## University of Colorado Design Review Board Meeting Notes

Date: Thursday, February 13, 2020  
Time: 8:30 – 3:30 p.m.  
Location: First Floor Conference Room, 1800 Grant Street, Denver

### **10:00 a.m. – 12:00 p.m. UCHealth University of Colorado Hospital Garage 2 – CU Anschutz Medical Campus Conceptual Design (Action Required)**

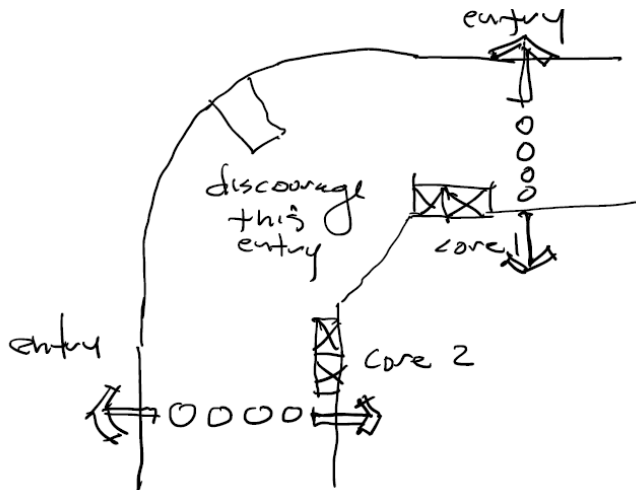
- The DRB agreed with the design team's preference for an east-west orientation option for the proposed garage structure.
